Revised Revenue Proposal to AER 2018-2022

**Review of Powerlink's replacement
capital expenditure**

Australian Energy Regulator

Energy Market Consulting associates

Figure 2: Weighted mean tower replacement lives – peer comparison (years)

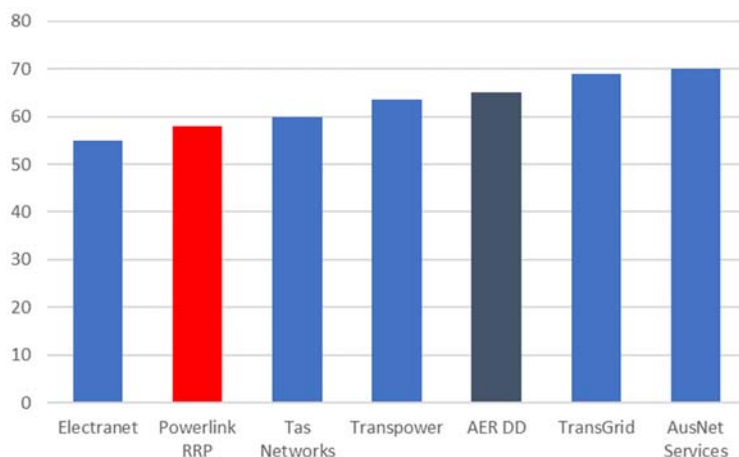
- 102. As discussed in an earlier section of this report, we consider that Powerlink has not justified the inclusion of maintenance interventions for its calibrated replacement quantities relating to all three corrosion zones. As shown in Table 11, the removal of the maintenance intervention quantities results in mean replacement lives for each of the three corrosion zones that are more similar to the mean replacement lives proposed by the AER, as shown in Table 12.

- 103. Figure 2 shows a comparison of weighted mean replacement lives for a selection of peer utilities.⁴⁶ This graph indicates that the AER’s adjusted results are not ‘unrealistic’ compared to Powerlink’s peer utilities (as claimed by Powerlink) and that Powerlink’s RRP mean tower replacement life is the second lowest of its peer group. In compiling this information, Powerlink reference TransGrid’s Network Management Plan 2013-2018 to explain that its mean tower replacement life is only likely to be achieved following a life extension activity.⁴⁷

Figure 3: Mean CB replacement lives - peer comparison (years)

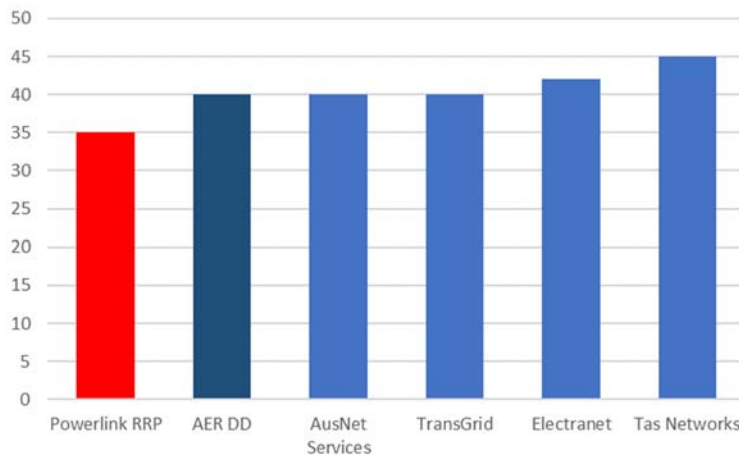
- 105. Figure 3 shows the mean circuit breaker (CB) replacement lives from other transmission utilities, the AER’s Draft Decision, and Powerlink’s RRP.⁴⁸ This indicates that the AER adjusted results are not ‘unrealistic’ compared to peer utilities (as claimed by Powerlink), and that Powerlink’s RRP mean CB replacement life is the lowest of its peer group.

- 106. Powerlink reported that its assessment of the actual replacement lives from the sample project documentation reviewed by EMCa resulted in a lower variance with Powerlink’s calibrated mean replacement lives.⁴⁹ We have reviewed our analysis and consider that the difference is likely to be a result of the approximations and assumptions that were used in determining the mean replacement life from the sample projects. The AER’s adjustment of +6 years to Powerlink’s RP values is less than EMCa’s derived average age at replacement from the sample projects (as reported in our Addendum report). The margin between the AER’s values and Powerlink’s revised values is now on average five years.

Figure 4: Mean secondary systems replacement lives – comparison (years)

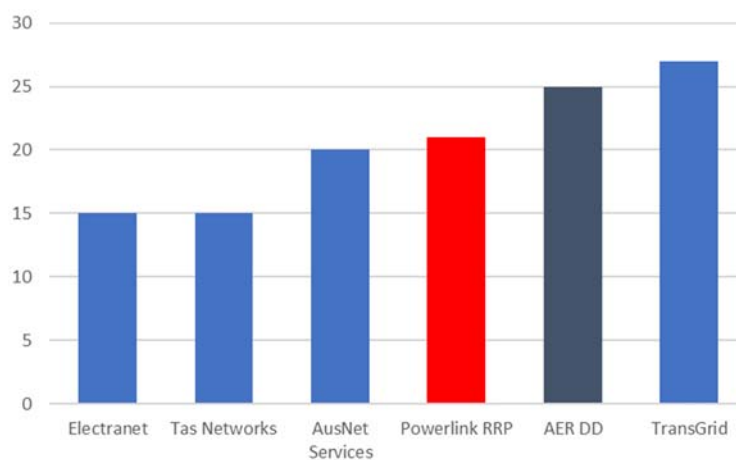
108. Figure 4 shows the mean secondary systems replacement lives from other transmission utilities, the AER's Draft Decision, and Powerlink's RRP. This indicates that the AER's adjusted results are not 'unrealistic' compared to peer utilities (as claimed by Powerlink) and that Powerlink's RRP mean secondary systems replacement life is higher than three NSPs in its peer group. In compiling this information, Powerlink reference TransGrid's Network Management Plan 2013-2018 to explain that Transgrid estimates that the expected life of new relays is between 15 and 20 years. Powerlink observes that this is likely to infer that the mean replacement life indicated in Figure 4 includes electro-mechanical relays.⁵⁰

109. Powerlink reported that its assessment of the actual replacement lives from the sample project documentation reviewed by EMCa resulted in negligible variance with the Repex Model mean replacement lives.⁵¹ We have reviewed our analysis and consider that our derived value is reasonable based on the information available. We note that the AER's Draft Decision value for secondary systems is less than EMCa's derived average age at replacement from the sample projects.
